## MAC SDU Fragmentation & Packing scheme for 16m

Document Number: C80216m-09\_0393r1

CR to SDD as per configuration control procedure (80216m-09\_0008)

Discuss and approve the proposed text changes into SDD document

Figure x: Fragmentation & Packing Extended header for 16m

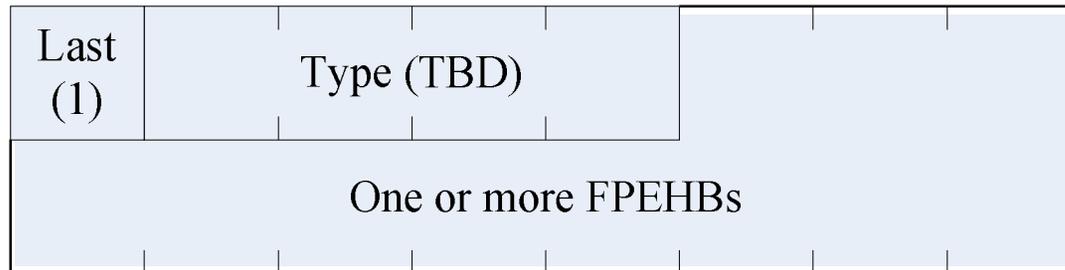
[ Insert the following text in section 10.12.2.1 in IEEE 802.16m-08/003r7]

IEEE 802.16m supports fragmentation of MAC SDU into one or more MAC PDUs and also allows the packing of one or more SDUs/SDU fragments in a single MAC PDU. The fragmentation and packing extended header is shown in figure x. FPEH is the last extended header present in the MAC PDU. FPEH consists of one or more Fragmentation and packing extended header blocks (FPEHBs). The number of FPEHB in FPEH is equal to number of flow payloads in the MAC PDU, which need fragmentation & packing info. Number of flow payloads which need fragmentation and packing info are present before other flow payloads, in a multiplexed MAC PDU.

Figure y: Fragmentation & Packing Extended Block

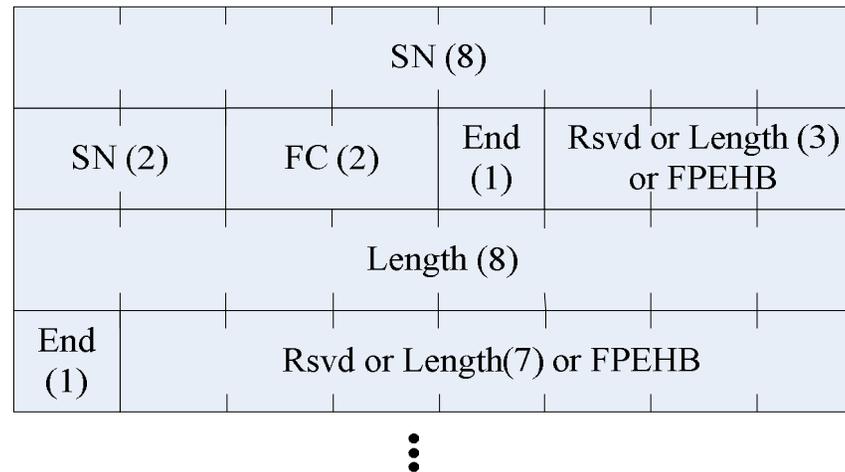
The fragmentation and packing extended header block is shown in figure y.

- SN : Payload sequence number
- FC : Fragmentation Control Bits definition are given in table y.
- End = 1: If this is the last FPEHB in FPEH, Rest bits for byte alignment of FPEH are reserved.  
If this is not the last FPEHB in FPEH, another FPEHB follows after the End bit.
- End = 0: Length and another End field are followed
